AGICF  
1.6  
5-18-87

May 18, 1987

Elliott Bay/Duwamish Action Team (EBAT)  
Dept. of Ecology, N.W. Regional Office  
4350 - 150th Avenue N.E.  
Redmond, WA 98052

Re: Our letter dated May 11, 1987.

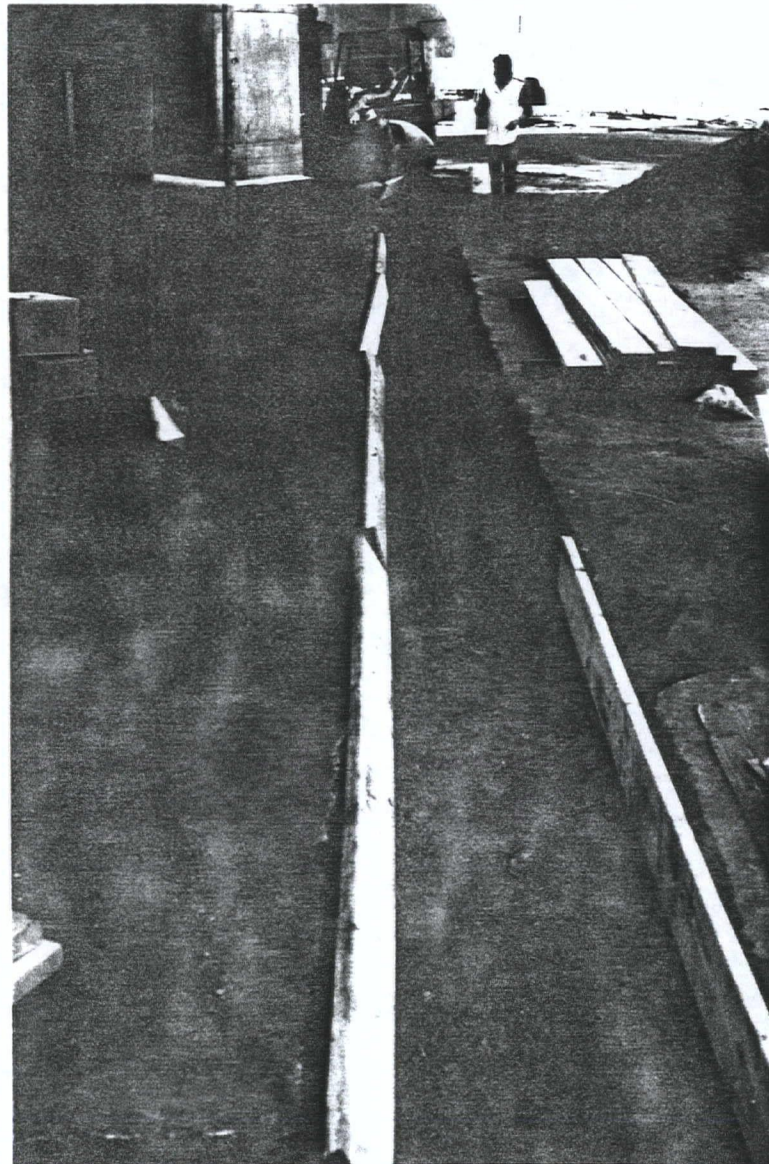
Requirement: Barrels of Iron Sulfate and other By-products of the Galvanizing Process are to be separated by composition and color; barrels numbered and objective, discretionary samples taken for chemical analysis. Results of the analysis will determine disposal procedures in compliance with Chapter 173-303 and 173-304, WAC, and RCW's 70.95 and 70.105. Seattle/King County Health Department is to be contacted to determine extent of analysis. Barrelled By-products will be tested by groupings - these groupings will be determined by the composition and various colors of the barrelled By-products. Additionally, the outdoor area where the barrelled By-products are currently stored is to be cleaned.

Status: All barrelled By-products have been separated by composition and color; barrels numbered, and all barrels have been moved to a sheltered warehouse area for protection from the elements pending disposal instructions to be received from Seattle/King County Health Department. Additionally, the outdoor area where the barrelled By-products were stored has been cleaned and the area gravelled over as indicated in the

photos, numbers 1 and 2, attached below.

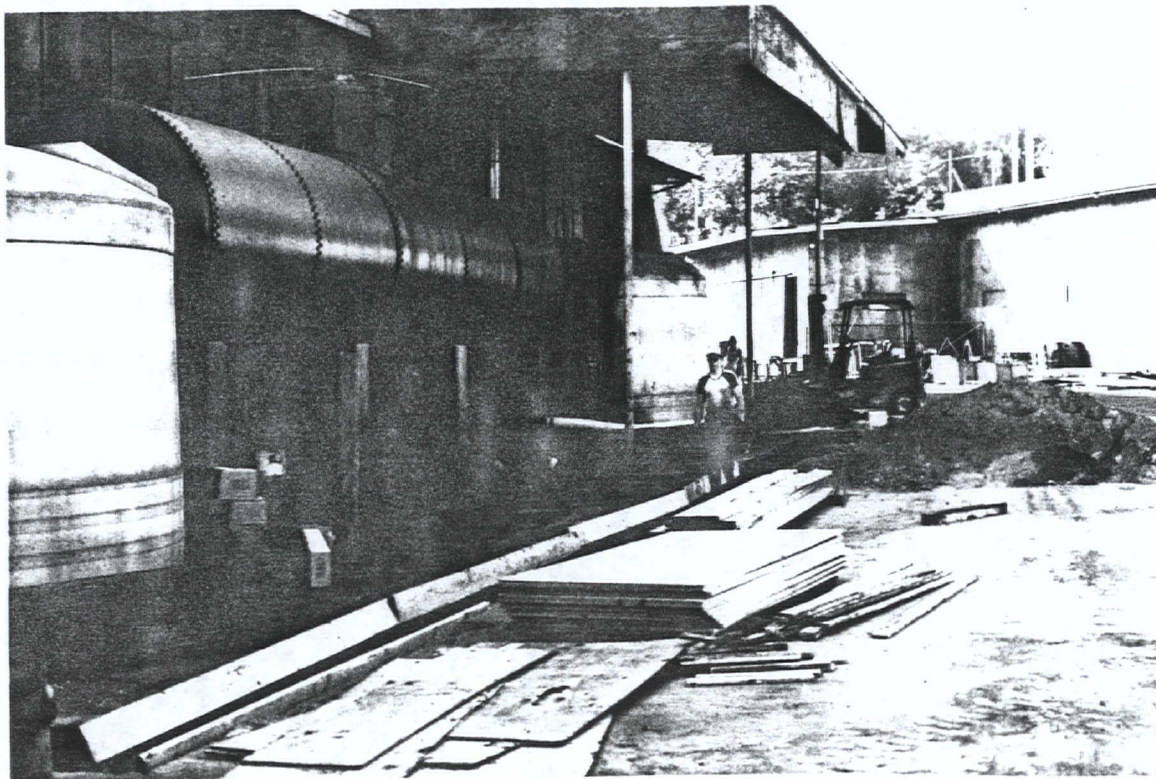
Requirement: Re-route surface run-off waters by construction of a berm at the south end of the Galvanizing Building, so that the run-off does not enter the galvanizing area, and then continue on into the Storm Drainage Sump. Additionally, there is a need to minimize the generation of uncontaminated water inside the galvanizing area. Uncontaminated water originates from two different sources: Surface run-off as indicated above, and drippings from the galvanizing rinse tank, where products to be galvanized are rinsed prior to "pickling". Surface run-off waters, generated by the two sources identified above, picked-up corrosives in the galvanizing area and drained into the storm drainage sump, resulting in an unauthorized discharge of water with a high acidic PH factor. To prevent this from occurring again, a requirement to contain the galvanizing area has been directed by DOE. The inspectors also questioned the disposition of the water that flows into a closed bottom sump located in the galvanizing area adjacent to the galvanizing tanks. Also, the inspectors pointed out the need to educate and train employees in the need to prevent surface run-off and the need for the Company to develop a Contingency Plan for Spill Prevention and Containment.

Status: Work has been initiated to re-route surface run-off away from the galvanizing building. A Concrete Berm will be constructed to direct the surface run-off flow to the storm drainage sump located at the southeastern end of the building. Additionally, a Retaining Wall is under construction that would contain any spillage from the storage tanks on the western side of the galvanizing building and also serve as a berm to direct surface run-off to the southeastern storm drainage sump (see photos number 3 and 4, below and on page five). This will be further described in our Drainage Plan to be submitted later to DOE.

Additionally, a Retaining Wall is under construction along the eastern side, and within the Galvanizing Building, where surface run-off with the high acidic PH Factor escaped into the storm drainage sump located at the southeastern corner of the Galvanizing Building. This Eastern Retaining Wall, located within the Galvanizing Building, will contain the process area as requested by the Response Team. Additionally, the employees have received instruction and training concerning the need to prevent surface run-off and, in general, the need for better "housekeeping". Also, the Company has directed the Environmental Consultant to write a Spill Prevention and Containment Contingency Plan. A copy of this plan will be provided to DOE when completed.

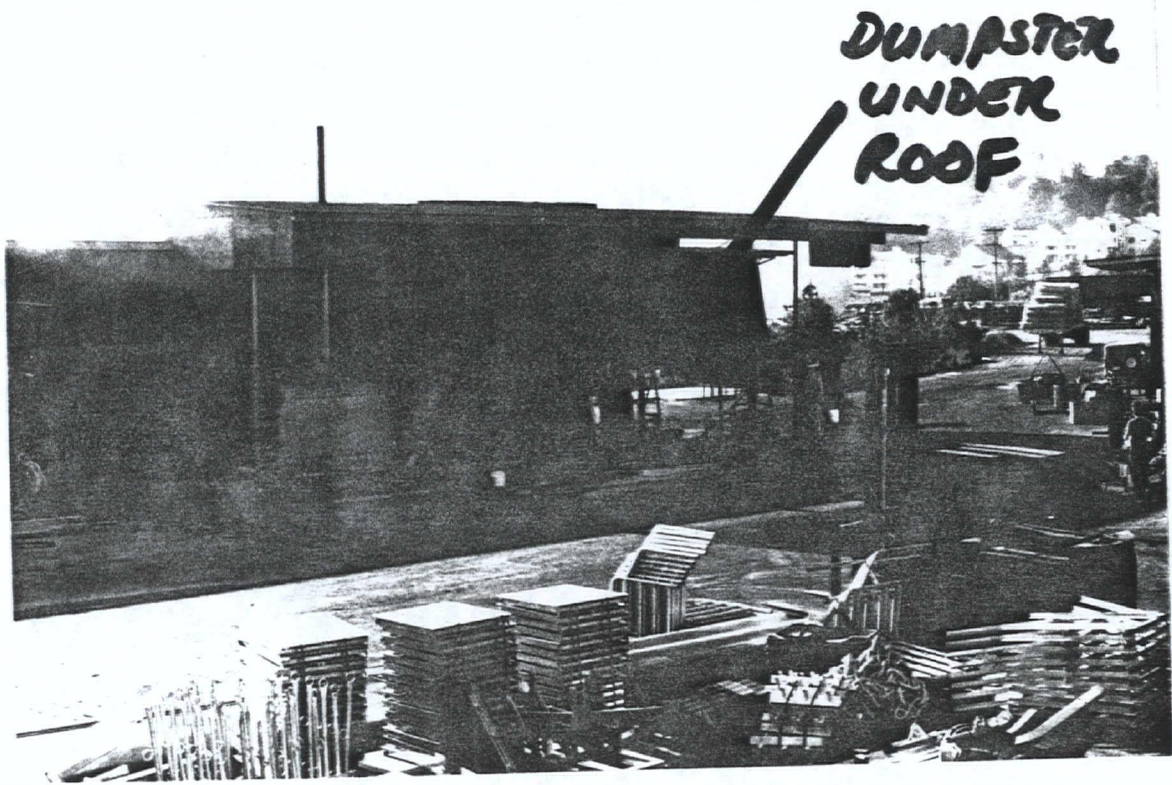
Requirement: Materials placed within the dumpster must be suitable for landfill disposal only. As is, the dumpster does not meet minimal functional standards in that there appears to be fluid running out the bottom, which contributes to the surface run-off problem. Need to place the dumpster in a "car-port" type structure where precipitation will not enter into the dumpster itself.

Status: Only wastes suitable for landfill disposal are placed in the dumpster. The dumpster will be placed under a permanent roof structure located on the western side of the Galvanizing Building, as indicated by the arrow on photo number 5 on page six. The dumpster will be in place as soon as the retainer wall and run-off berm have been completed.

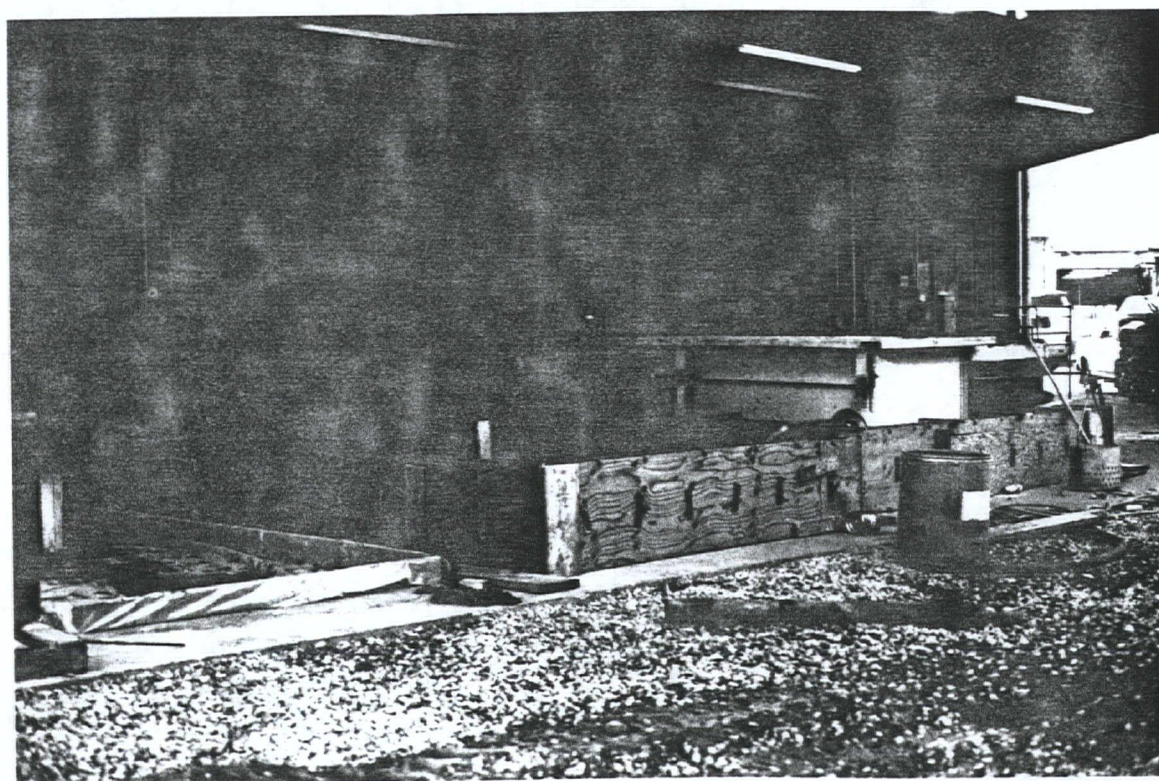
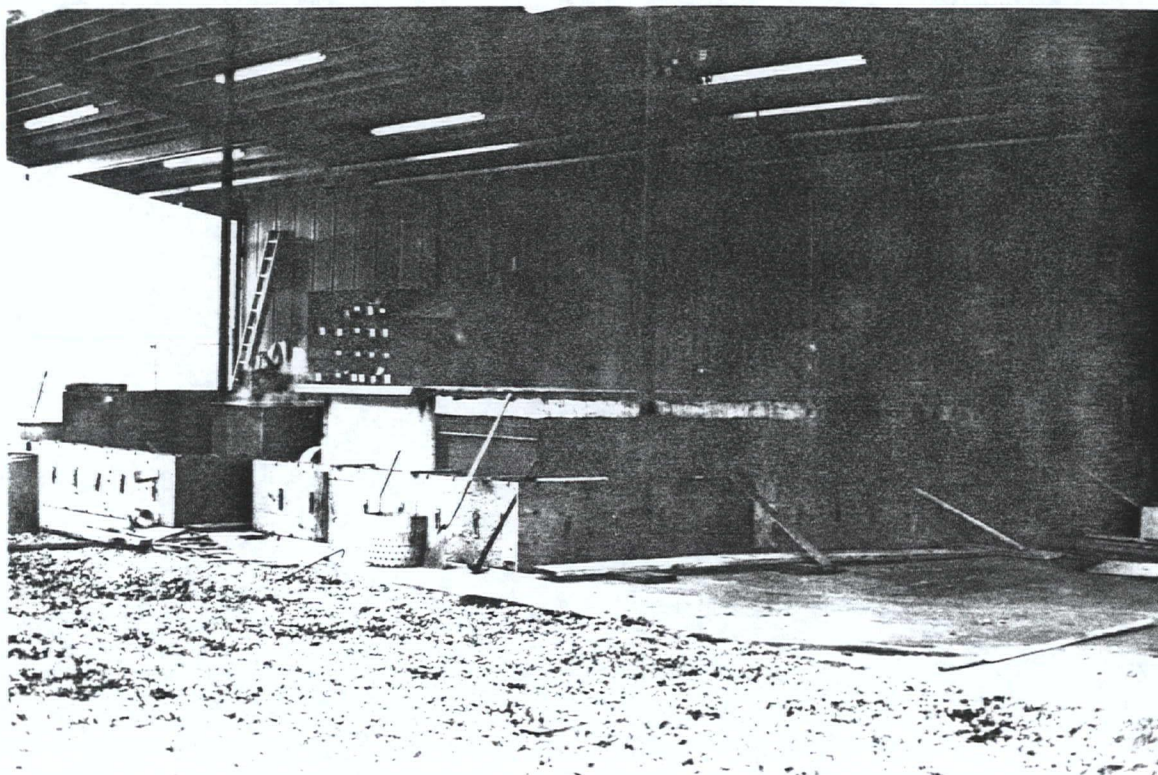
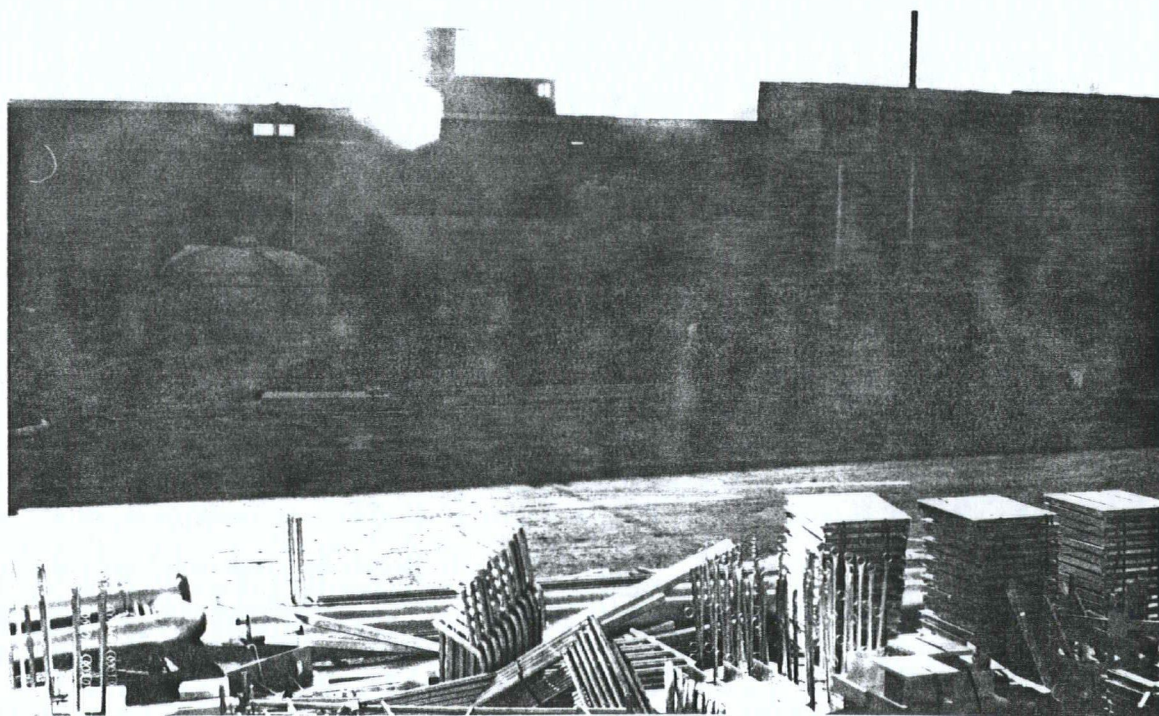
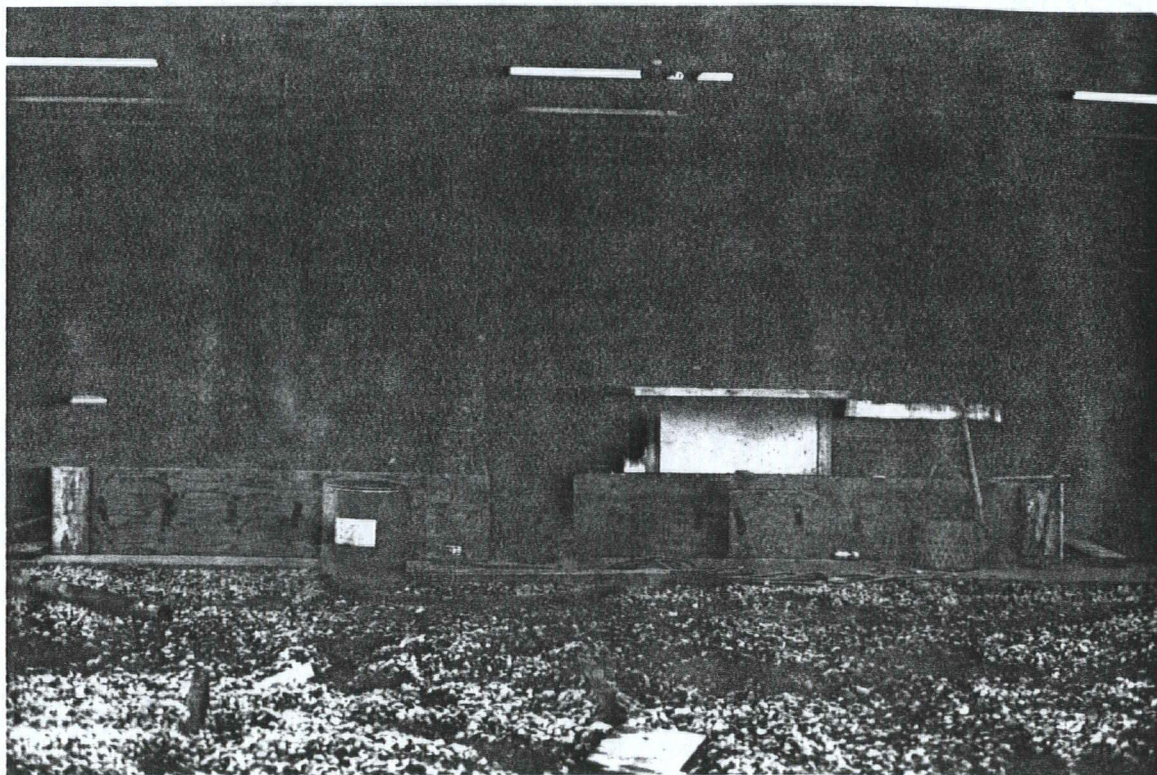
Requirement: Surface run-off must be kept out of galvanizing and other process areas. Process area must be contained and surface run-off minimized so that process materials are not "tracked" by employees and equipment to other areas of the plant site, and then eventually into the storm drainage system.

Status: Containment in the form of retaining walls and run-off berms are under construction throughout the facility. Employees have also been trained to improve "housekeeping" operations. Photos number 6 through 9 demonstrate on going containment construction.

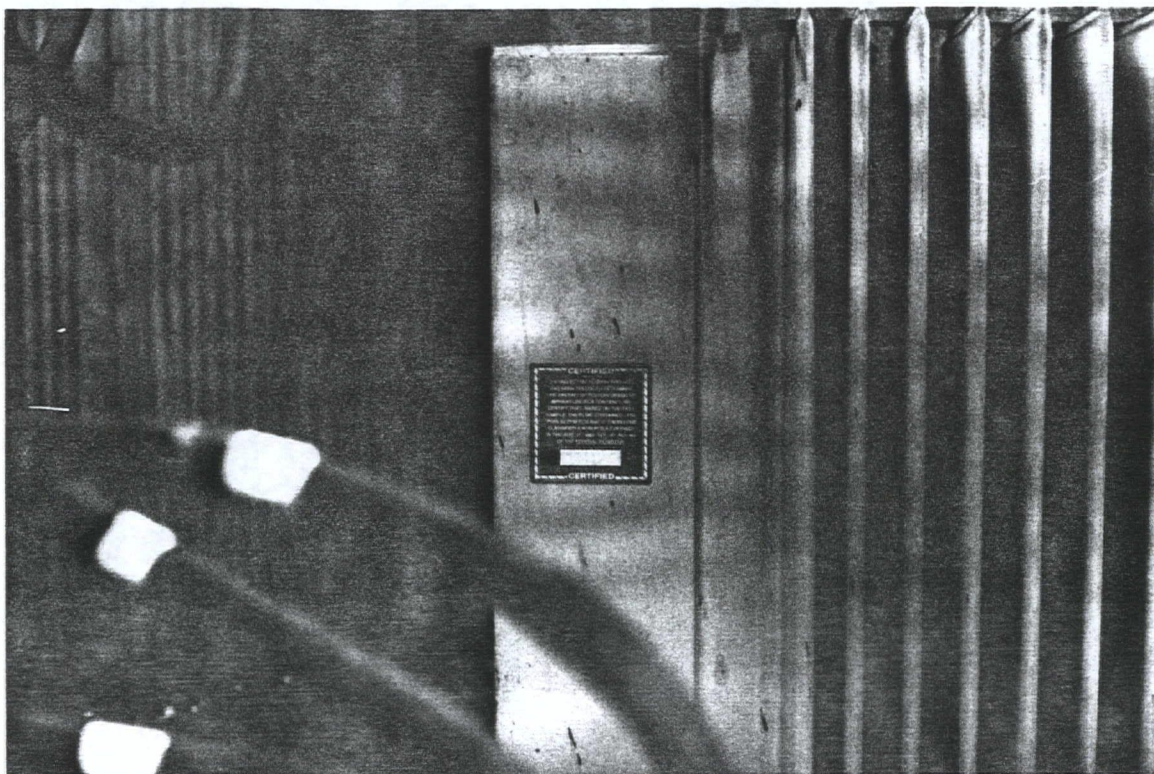
Requirement: Subject area needs to be cleaned. An electrical transformer is located in this area that could contain PCB's. Please verify and clean according to PCB concentration (if any). Also, notify employees accordingly. Additionally, the area around the air compressor tank needs cleaning as well as the area around the gasoline pump. Also, the western bank adjacent to the stairs to the lower yard level needs to be cleaned.

Status: The electrical transformer was closely inspected and a certification by Seattle City Light indicates that the oil contains less than 50PPM/PCB. Nevertheless, the area is fenced and secured from employee intervention. See photo number 10, below, indicating inspection decal.
